KEENE INFRASTRUCTURE IMPROVEMENTS **PHASE 2 PRELIMINARY DESIGN** **CENTRAL SQUARE**

MSFI COMMITTEE MEETING

MAY 22, 2024

SIGNAL PHASING - U-TURN ALTERNATIVE

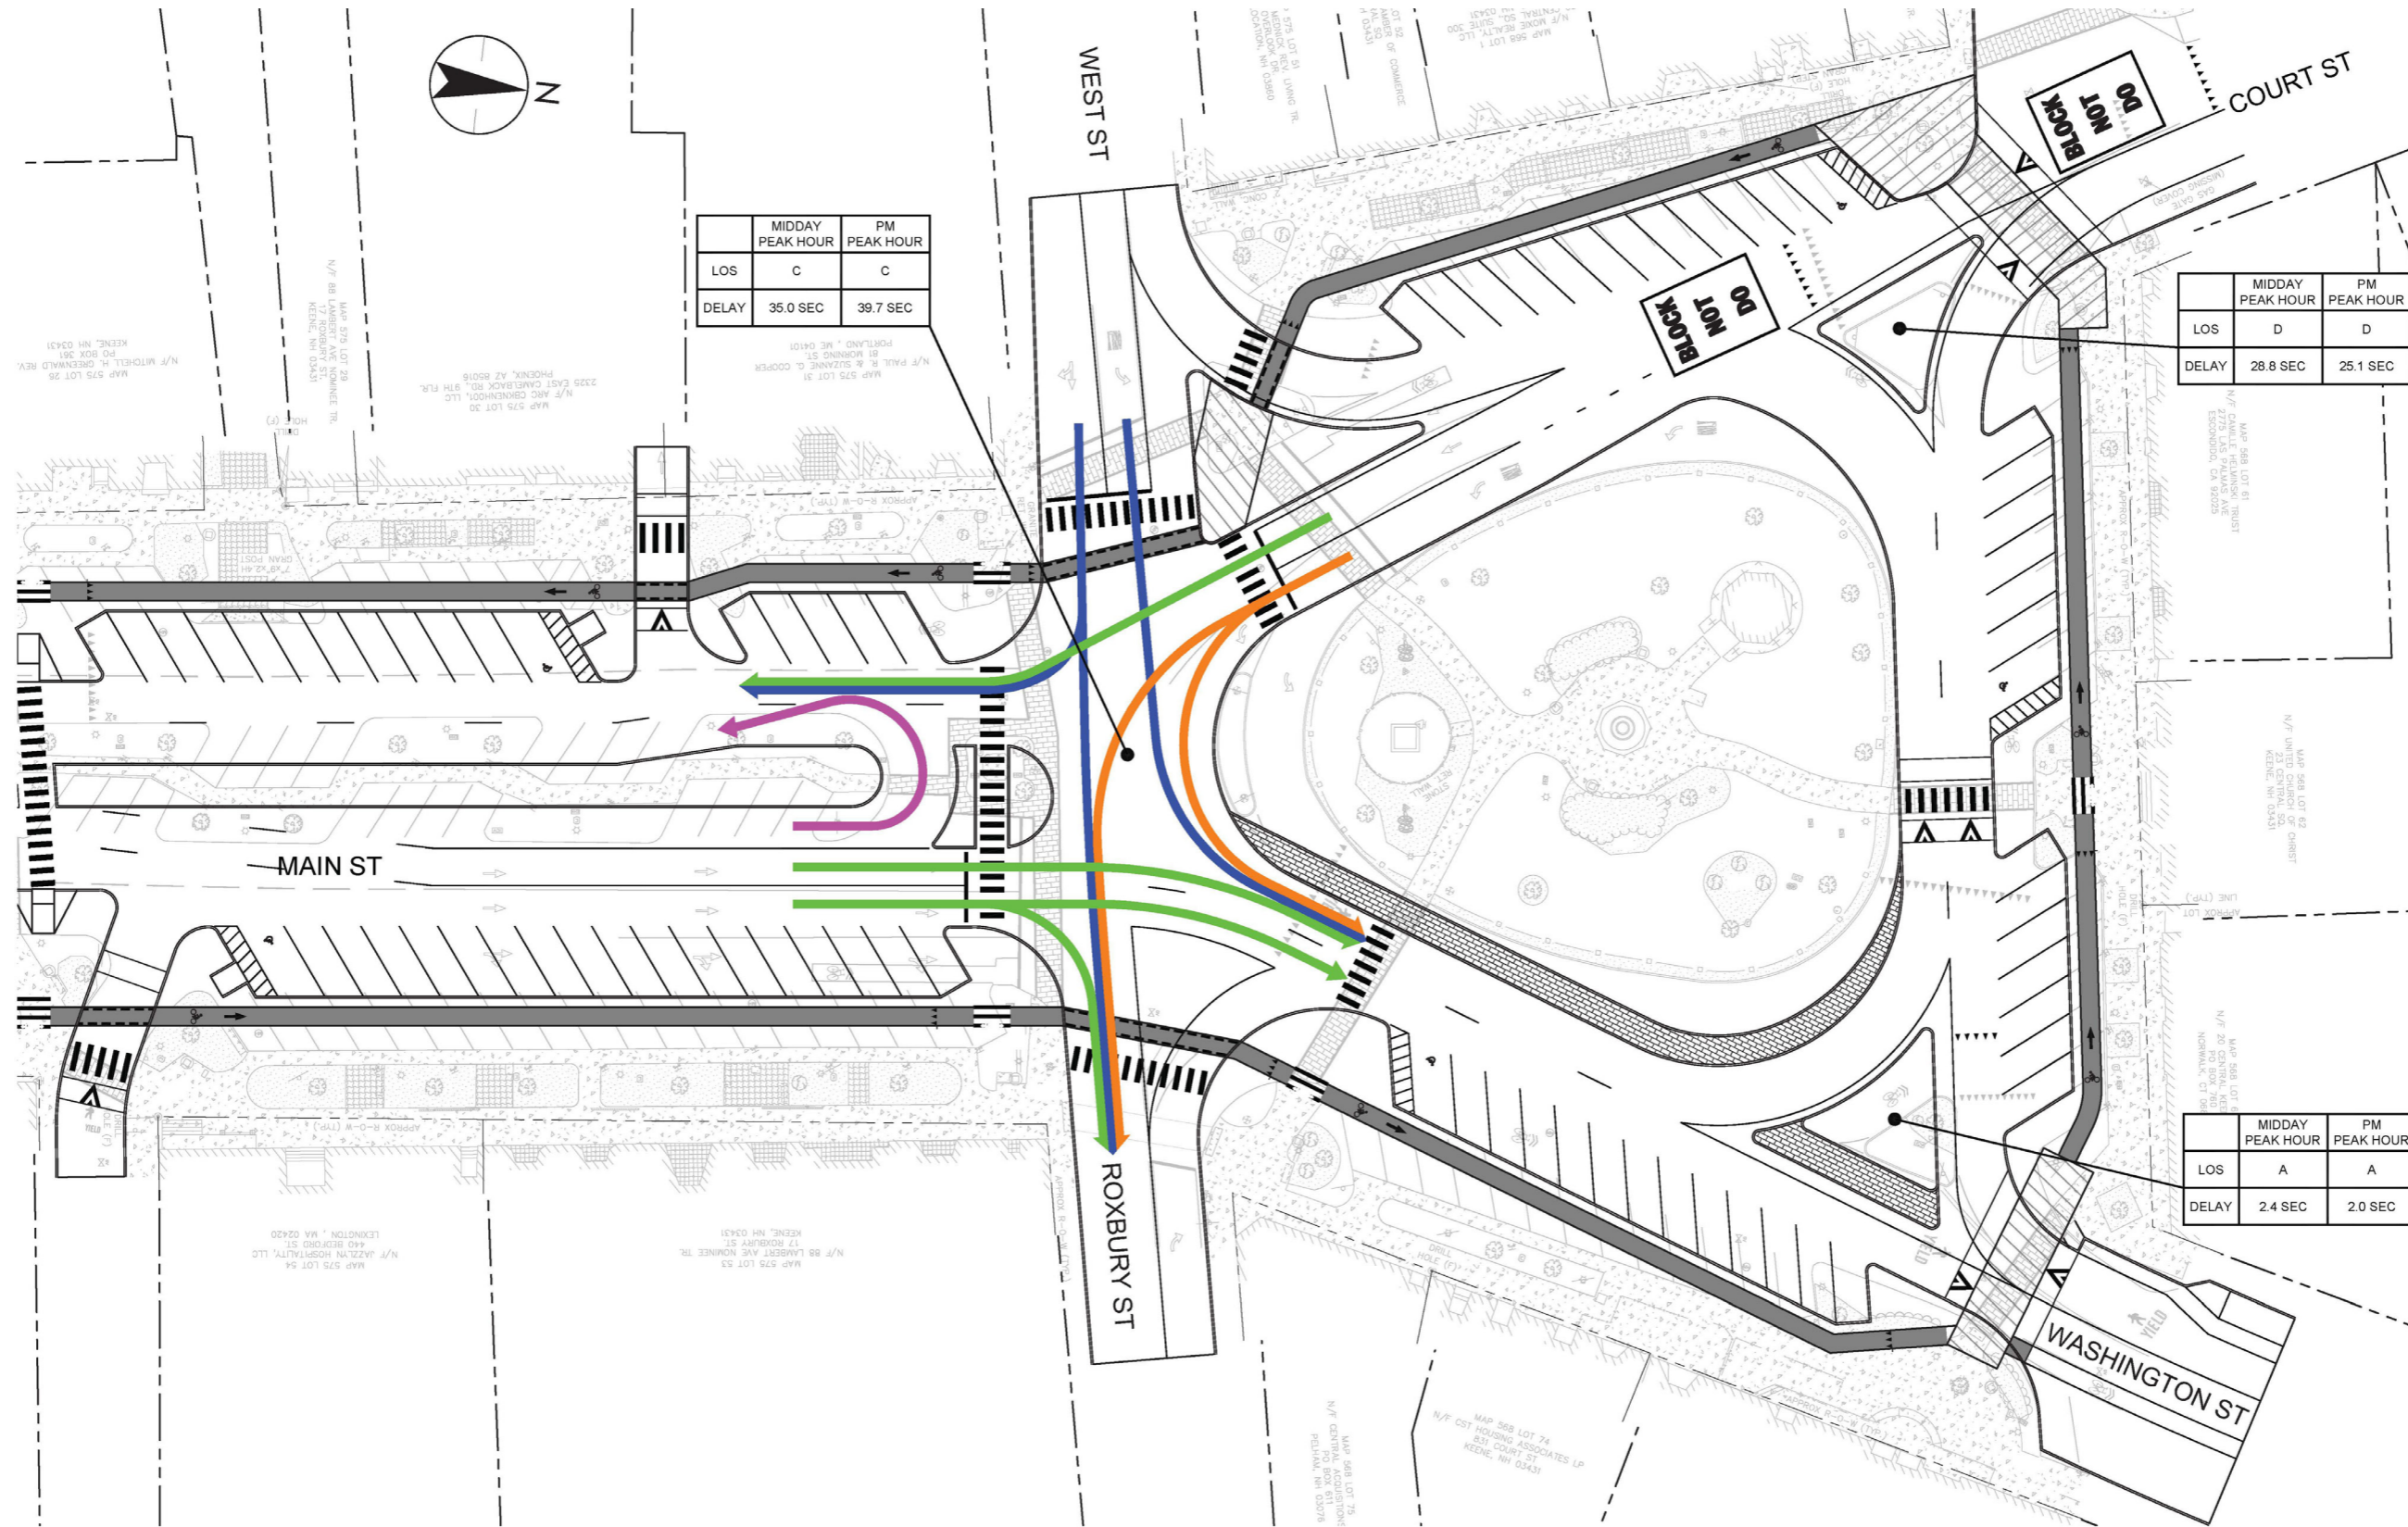
- The U-turn south of the intersection had the most support of the U-turn alternatives.
- The single/double lane across the top of the square was mixed, about 50/50 between the two alternatives.
- General concern that reducing from two southbound through lanes to one will create backups along Court and across the top of the Square.
- Strong support for the raised crosswalks and RRFB(Rectangular Rapid Flashing Beacon) as shown.
- Concern with reducing to a single left turn lane from crossover to Court/West Street.

PEDESTRIAN & BIKE CROSSINGS

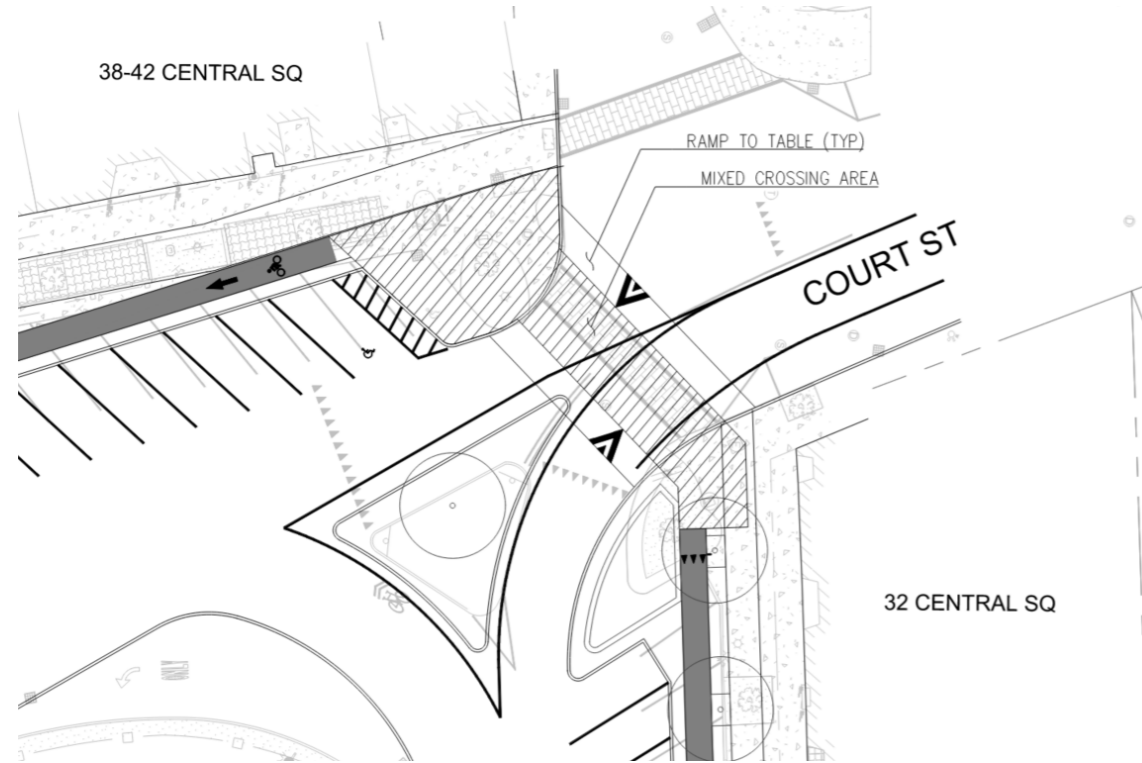
- Mixed reactions on RRFBs(Rapid Rectangular Flashing Beacon), trended towards against but some people were in favor of adding one at the midblock in front of the Church
- Positive feedback about raised crossings
 - Question on material/signage to indicate it's a space for both peds and bikes
- Some concerns over roadway narrowing, but positive feedback about improved streetscape width

EXISTING ELEMENTS

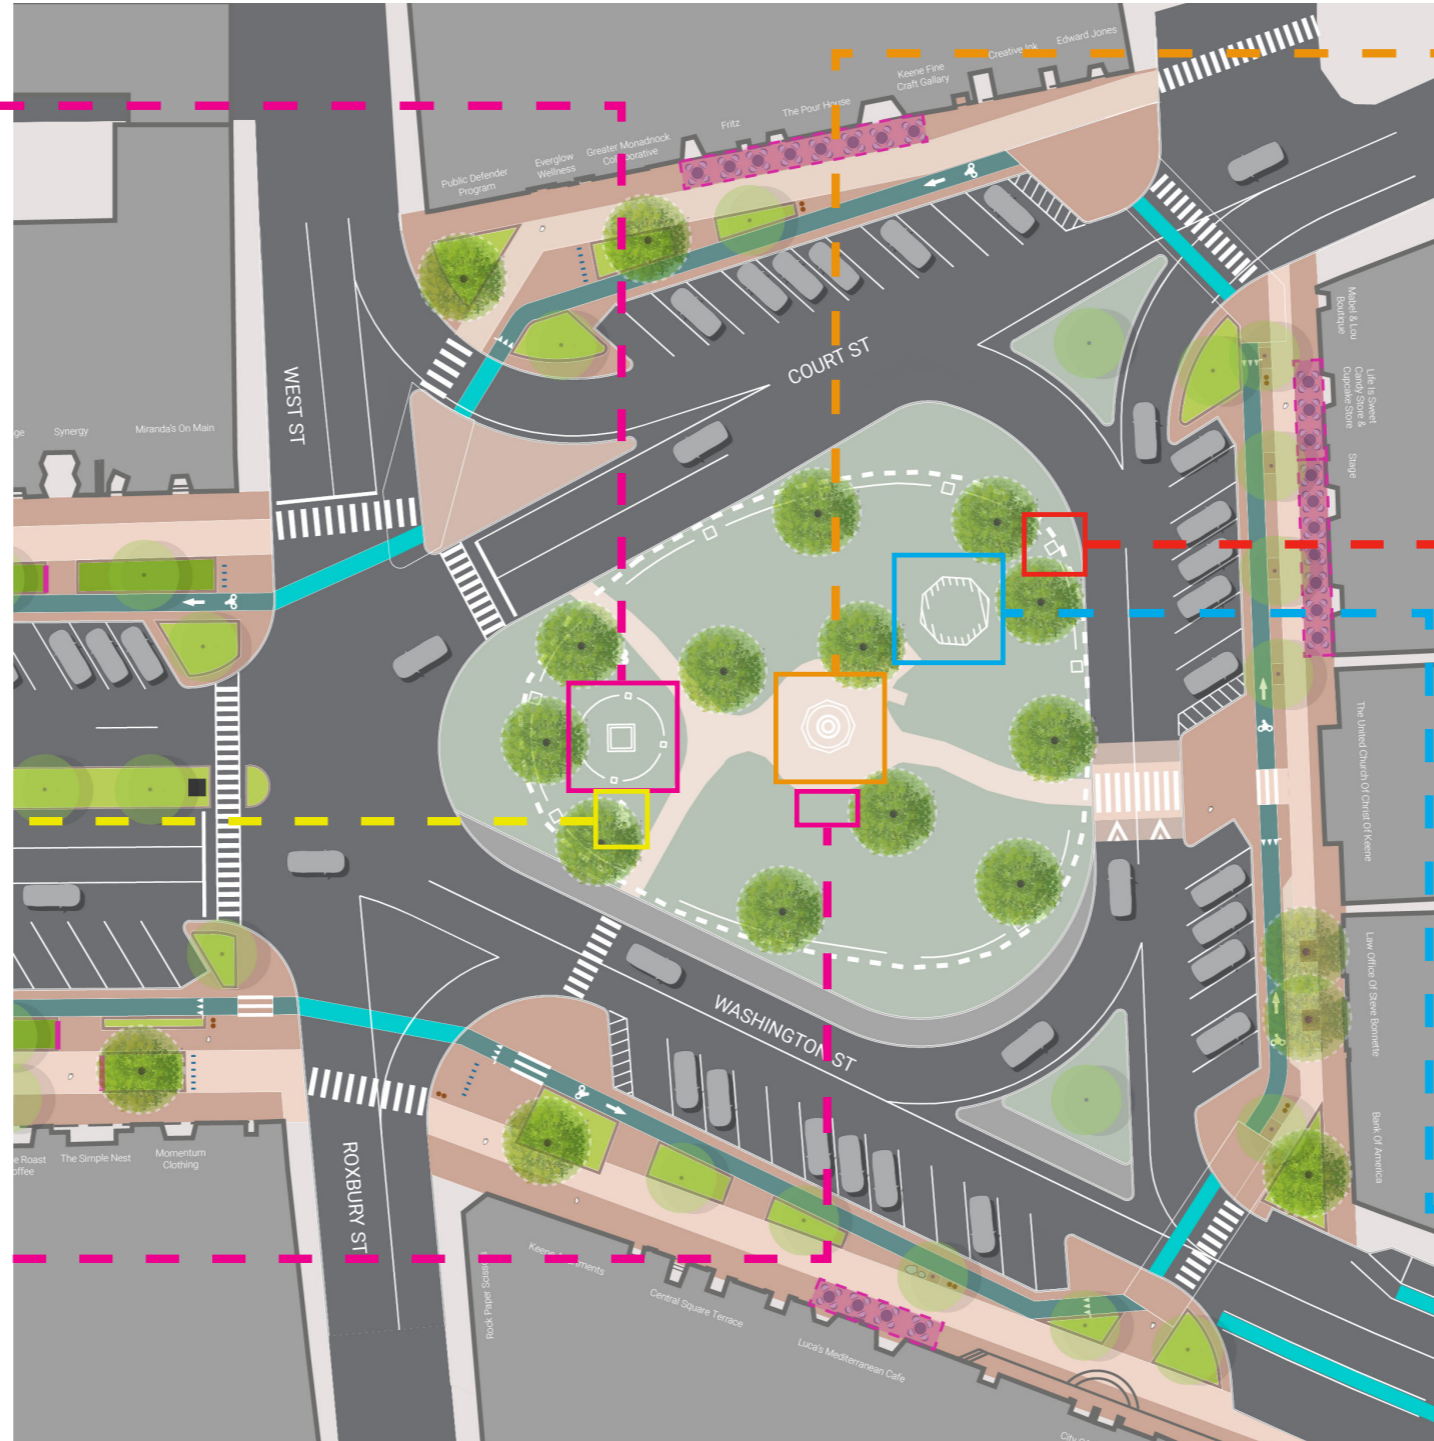
Soldiers' Monument - Should statue be moved out to the nose to be more prominent?

Cannon - Should cannon/cannonballs be moved out to the nose to be more prominent?

Bench - Should more bench seating be provided?

Bollard - Granite post and chain detail to be moved to perimeter?

Gazebo/Bandstand - Should Gazebo/bandstand be moved to provide more space around it? prominent?

OPTION 2 - ENHANCED

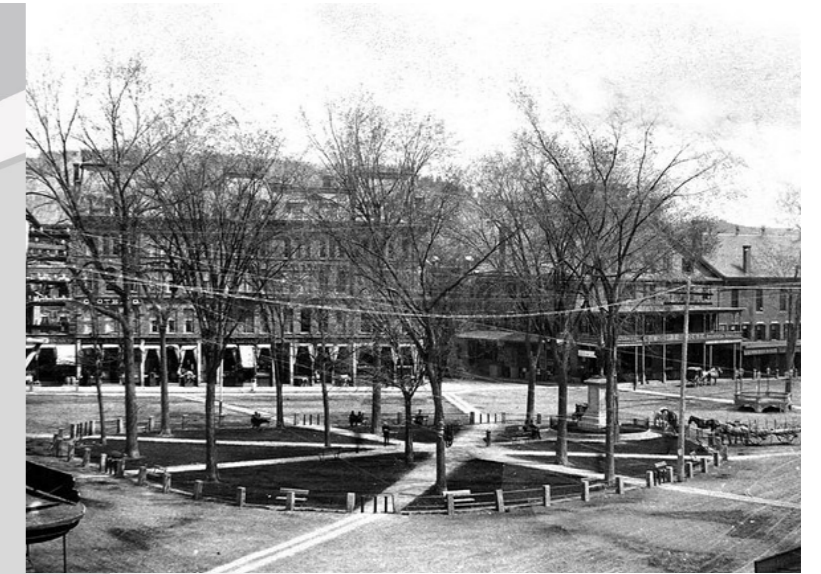
- General preference for Option 1 Minimal and Option 3 New

- People liked the directness of the paths, especially the connection from Court St to Washington St crossing, beneficial for when there are performances and want to avoid the crowd near bandstand
- People generally wanted to maximize the green space, felt the perimeter path was not needed and busy
- Concern about removing the honeylocust tree for the new path in Option 3
- Current number of benches are fine, people like to come with their own chairs and blankets for performances
- General preference for brick or unit pavers as accents in key areas
